URGENT FIELD SAFETY NOTICE

RE: SINGLE USE LIGATING DEVICE POLYLOOP

Material ID	Model Number	Material Description	Lot Numbers	UDI
N5382130	HX-400U-30	SINGLE USE LIGATING DEVICE POLYLOOP	See attachment	04953170368615

Operation Pipe breaking

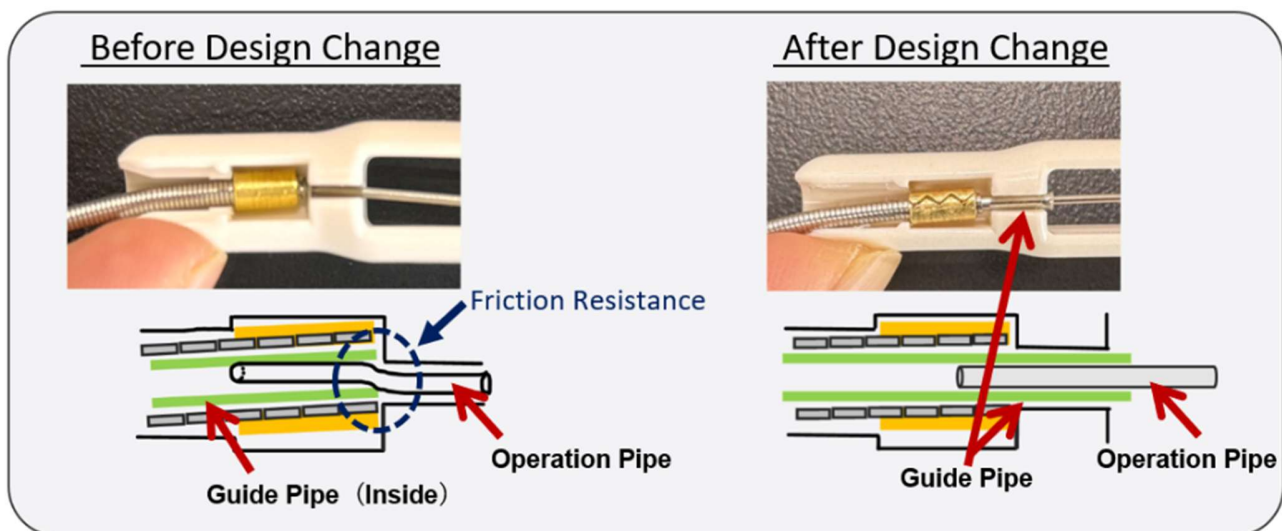
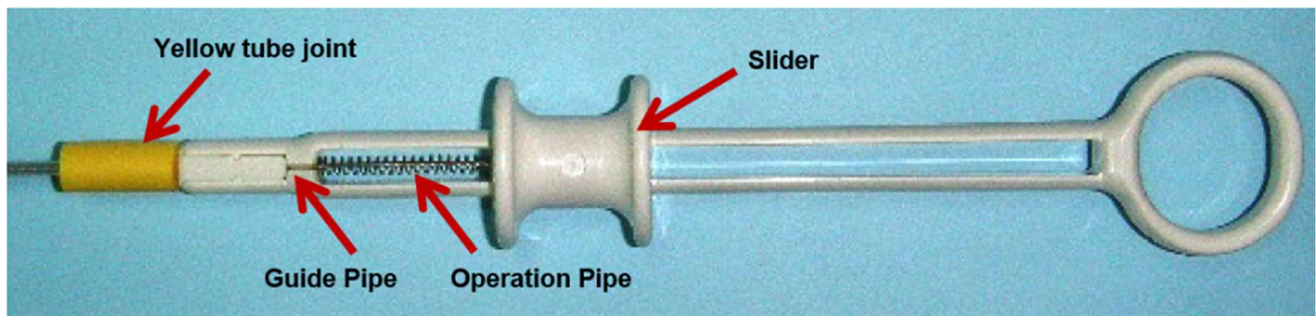
Olympus is introducing a design change to address complaints that the ligation loop was unable to release or detach as expected during use, with operation pipe breakage being one of the contributing factors to these complaints. (see image below).

Olympus revised the method used to secure the guide pipe. As a result, even if the sheath near the handle is not fully straightened, the operation pipe can be prevented from bending as shown in the figure.

■ **Do not hold the loop with the distal end of the tube sheath while the loop is surrounding the tissue. (refer to page 5 in the manual)**

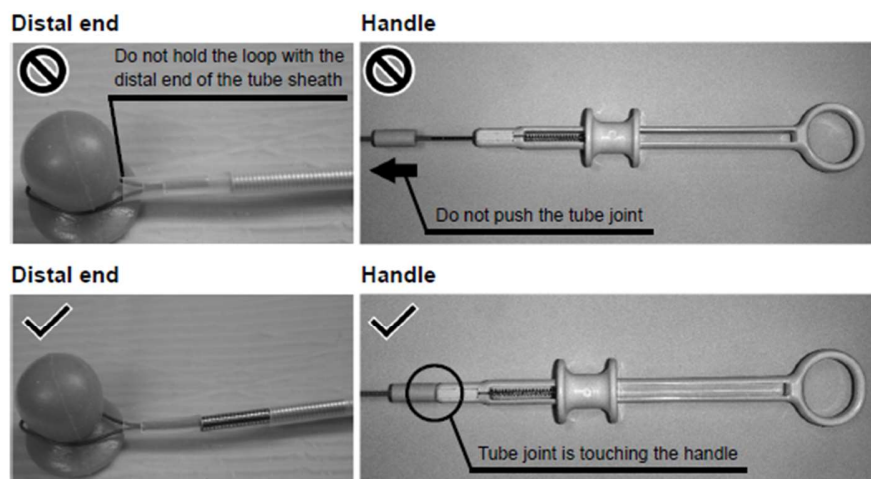
Otherwise, when the tissue is ligated, the loop may be detached from the hook in the tube sheath and tangled with the hook.

- **Do not remove the loop from the hook while the coil sheath is not extended from the tube sheath. (refer to page 6 in the manual)**

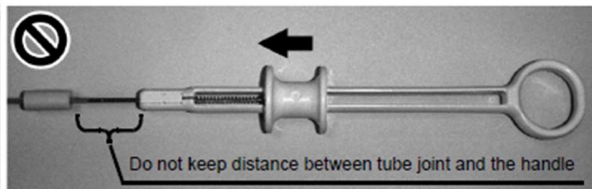
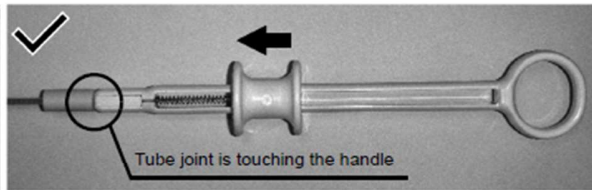
Otherwise, the loop may be tangled with the hook and become impossible to be removed.

- **With the proximal end of the tube sheath and handle kept straight against the biopsy valve of the endoscope, push the slider when detaching the loop. (refer to page 6 in the manual)**

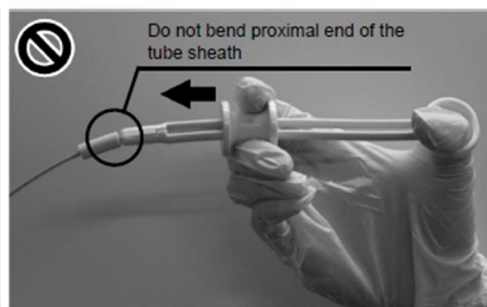
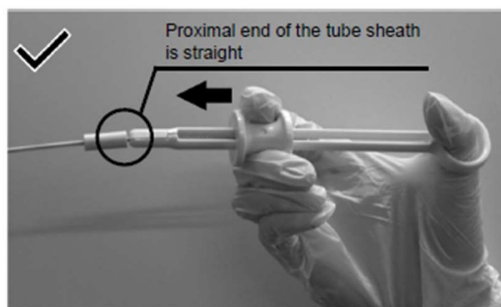
Bending the proximal end of the tube sheath will increase frictional resistance, which may damage the handle when pushing the slider.
